Subject: Lee Road Extension Traffic Analysis Review

Comprehensive Engineering Services, Inc. (CES) has reviewed the traffic analysis submitted for the extension of Lee Road and the development of the site which includes a Whole Foods on the east side of US 17/92 in the City of Winter Park. In addition, we have met with the Developer's Engineers to obtain a more complete understanding of the traffic impacts and the methodology used in their analysis. The primary purpose for the proposed Lee Road extension is to provide relief to congestion along US 17/92 and to enhance access to the site at the US 17/92 intersection. For the Florida Department of Transportation (FDOT) to allow this connection, improvements that mitigate the added delay associated with the additional signal time to service the fourth leg of the intersection are required. FDOT has indicated that the only way to mitigate the added approach to the intersection is for Lee Road to be extended further to the east to provide relief for delay associated with the movements to and from Lee Road and Webster Avenue.

Figure:
PROPOSED LEE ROAD EXTENSION - ALTERNATIVE ALIGNMENTS

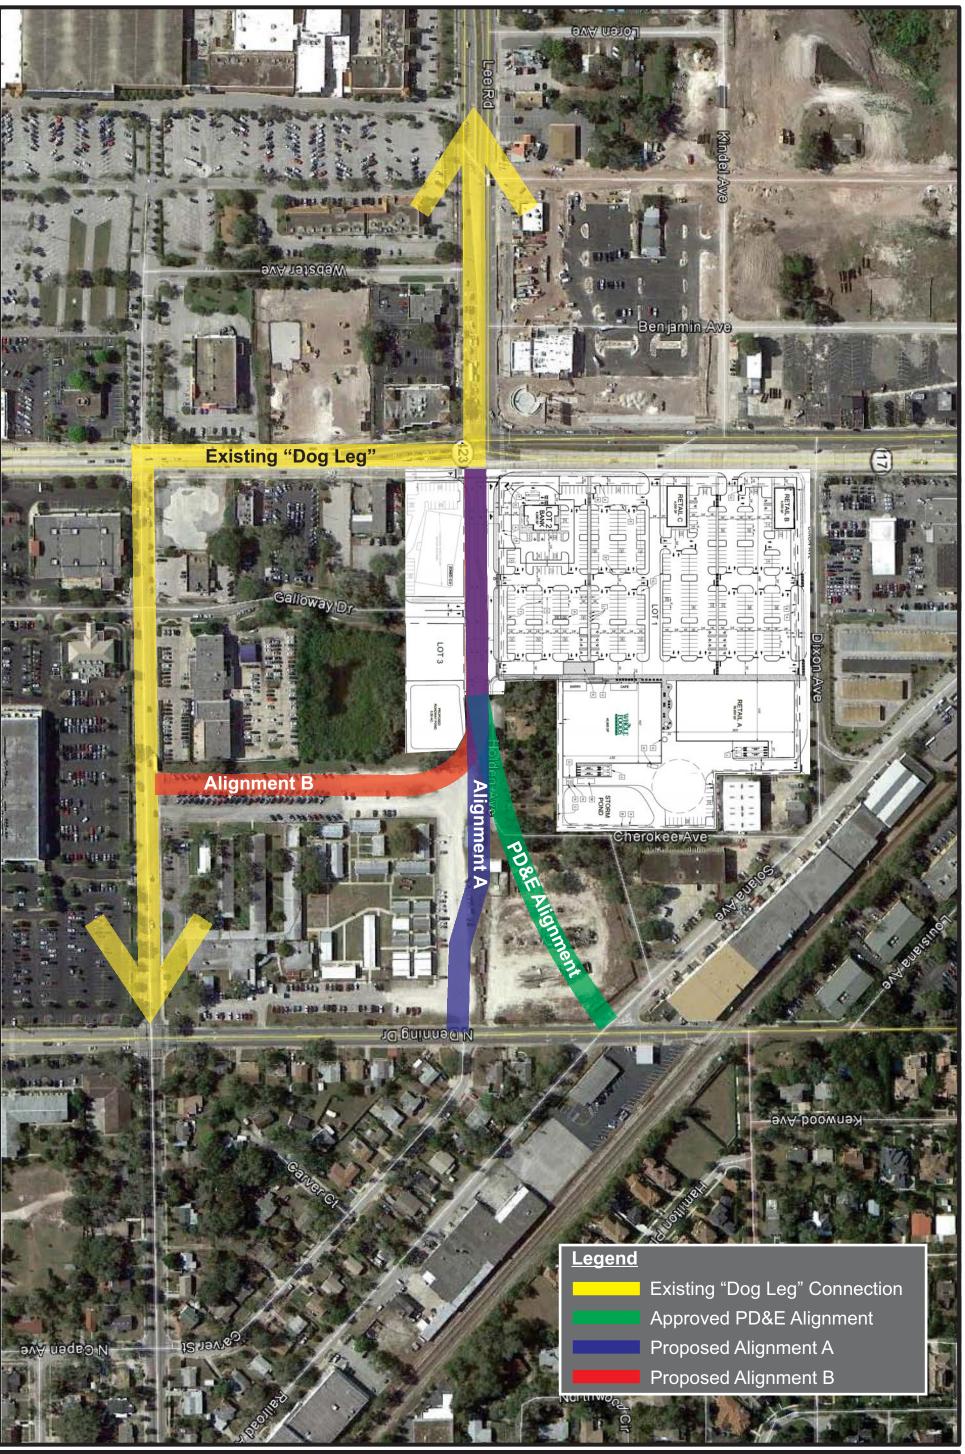
The Developer's team analyzed three alternatives for the extension of Lee Road to the east which are depicted in the attachment listed as Figure 3 from the Developer's Traffic Analysis Report and include:

- 1. For the first alternative based on the 2004 PD&E, consideration should be given to utilizing a roundabout for the intersection of Lee Road with Denning Drive, Solana Avenue and Railroad Avenue. This alternative offers the best connectivity to the neighborhoods to the north and east which may be desirable to some and undesirable to others that are concerned about cut-through traffic. The roundabout may help mitigate this concern for some.
- 2. For Alignment A, We concur that with this alternative the eastbound lefts and through movements be prohibited at the intersection with Carver Street to mitigate cut-through traffic concerns. However, elimination of these movements may be undesirable to some residents who wish to shop at the proposed development.

3. For Alignment B, We concur with the recommendation that the southbound lefts from US 17/92 be prohibited at Webster Avenue. This Alternative would result in the most mitigation to existing traffic operational concerns on US 17/92. It would have the most noticeable improvements to the ongoing issues that result in delay caused by the northbound US 17/92 left turns at Lee Road and the southbound US 17/92 left turns at Webster Avenue. The queues associated with these movements significantly reduce the overall operational performance of these intersections and can also inhibit northbound/southbound traffic flow along US 17/92 between these intersections. This Alternative also gives the most reduction in perceived cut-through traffic into the residential communities to the north and east of the site. There does not appear to be any advantage for additional trips originating from North Park Avenue or Palmer Avenue to utilize this new connection. The traffic analysis prepared by the Developer indicates that a signal is not warranted for the new Lee Road connection to Webster Avenue. However, after construction the intersection should be studied for signalization warrants. It is anticipated that at some time in the future a signal will be warranted.

It is our recommendation that Alternative B with the elimination of the southbound left turn movement from US 17/92 to Webster Avenue be the preferred improvement. This alternative provides the most improvement to congestion along US 17/92 and the operations of intersections in the vicinity. This alternative also provides the most direct route for traffic that is currently traveling this way to and from the residential areas of Winter Park and for shopping/dining along South Park Avenue. Another positive consideration for this alignment is that it provides better multimodal connectivity to the Winter Park Village and other new development occurring to the south without relying on access from the already congested US 17/92 corridor.
